MICROCHIP PIC18F2423/2523/4423/4523

PIC18F2423/2523/4423/4523 Rev. B2 Silicon Errata

FIGURE 1: SCK PULSE VARIATION USING TIMER2/2

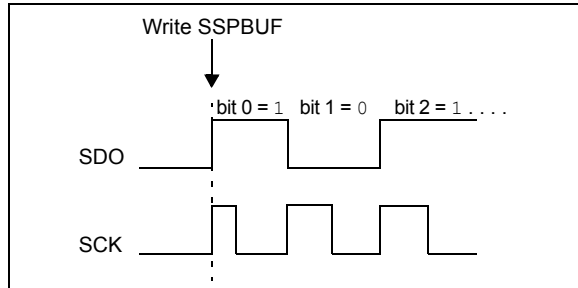
When the SPI is using Timer2/2 as the clock source, a shorter than expected SCK pulse may occur on the first bit of the transmitted/received data (Figure 1).

To avoid producing the short pulse, turn off Timer2 and clear the TMR2 register, load the SSPBUF with the data to transmit and then turn Timer2 back on. Refer to Example 2 for sample code.
